SUBJECT: Forwards revised response to NRC Question 361.016 re ground motion. Response informally transmitted on 820510 & will be incorporated into FSAR Amend 27.

Subject: NUCLEAR PROJECT NO. 2
REVISED RESPONSE TO NRC QUESTION 361.016

Question 361.16

Figure
361.16-7

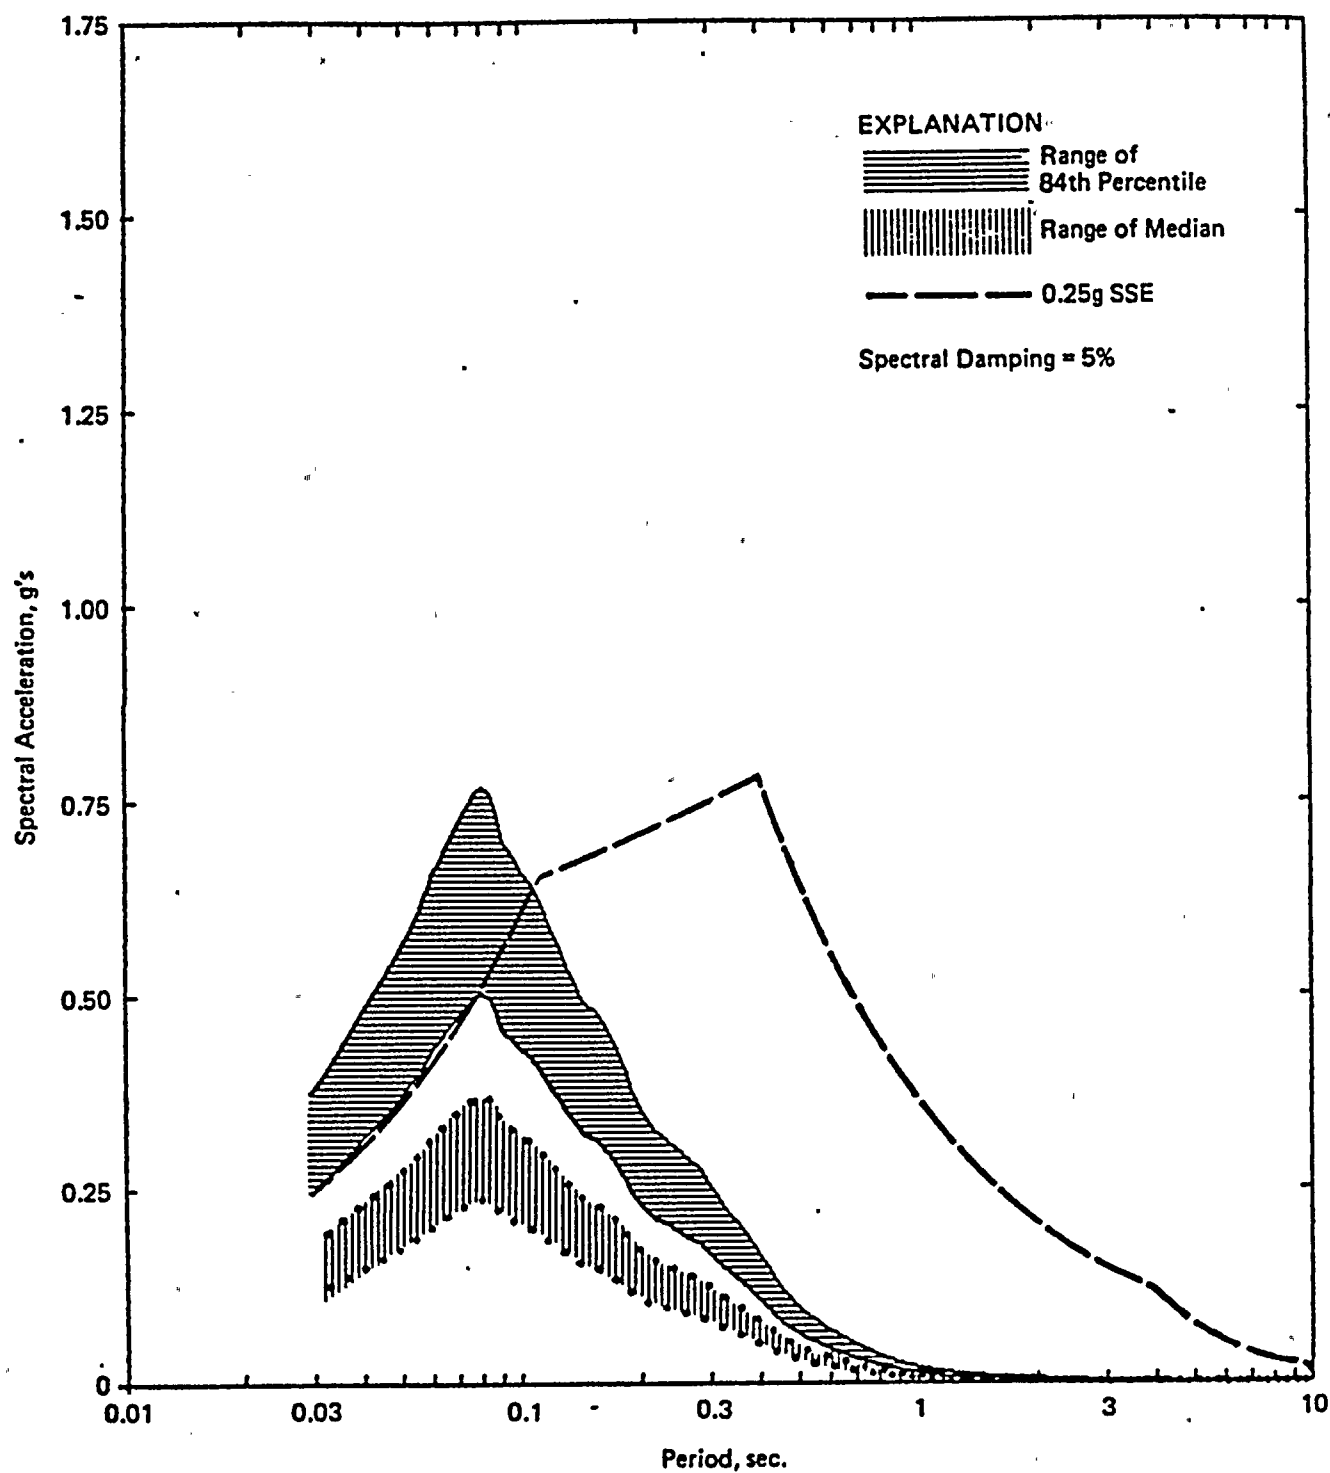
Estimate the ground motion (including high frequencies) assuming a magnitude $M_L = 4.0$ (largest swarm event in the Columbia Plateau) occurred at a distance of 3 to 5 kilometers from the site. Compare the response spectra from this event to the SSE response spectra. Also, state your position on how large and close a potential swarm earthquake could come to the site.

Multiplying the above corrected accelerations by the median spectral shape, median and 84th percentile response spectra are obtained. Figures 361.16-7 through 361.16-9 compare the resulting response spectra at distances of 3 to 5 km with the 0.25 g SSE spectrum for 2 percent, 5 percent, and 7 percent spectral damping, respectively. As can be seen, the 0.25 g SSE spectrum is only exceeded for frequencies greater than 10 Hz. It is noted that multiplication of the median peak accelerations by the 84th percentile spectral shape results in lower absolute spectral accelerations than those shown on Figures 361.16-7 through 361.16-9 for periods less than 0.3 seconds. This is because the dispersion in peak acceleration is greater than the dispersion in spectral shape.
